Subject: FW: Pevensey Road, BR/277/20/DOC

From: Elvin Gomery [REDACTED]
Sent: 16 December 2020 09:35
To: Laura Gibbons [REDACTED]
Cc: Stuart Bone [REDACTED] Maria Tomalova <Maria.Tomalova@arun.gov.uk>
Subject: RE: Pevensey Road

Subject: Re: Pevensey Road

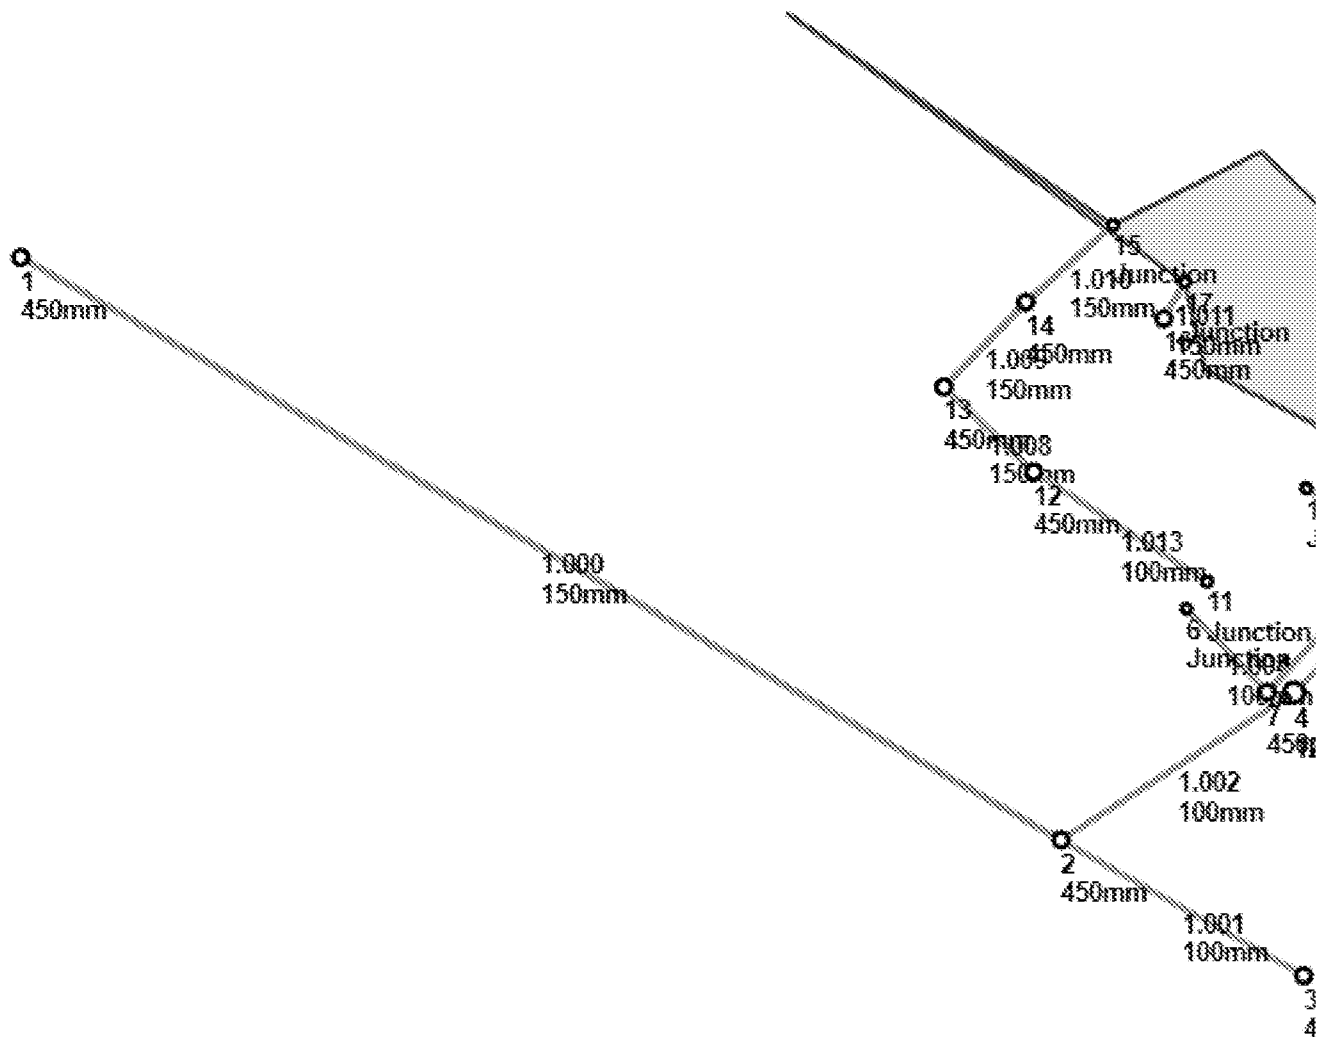
1. FEH rainfall or a Cv of 1 must be applied to calculations. Adjusted for a cv = 1.0
2. Nodes and pipe numbers should be labelled on plan to correspond with the modelled network to facilitate review. The flow file would also help my review, if possible please include this in your revised package of information. I have included the model sketch below and enclosed my FLOW file.
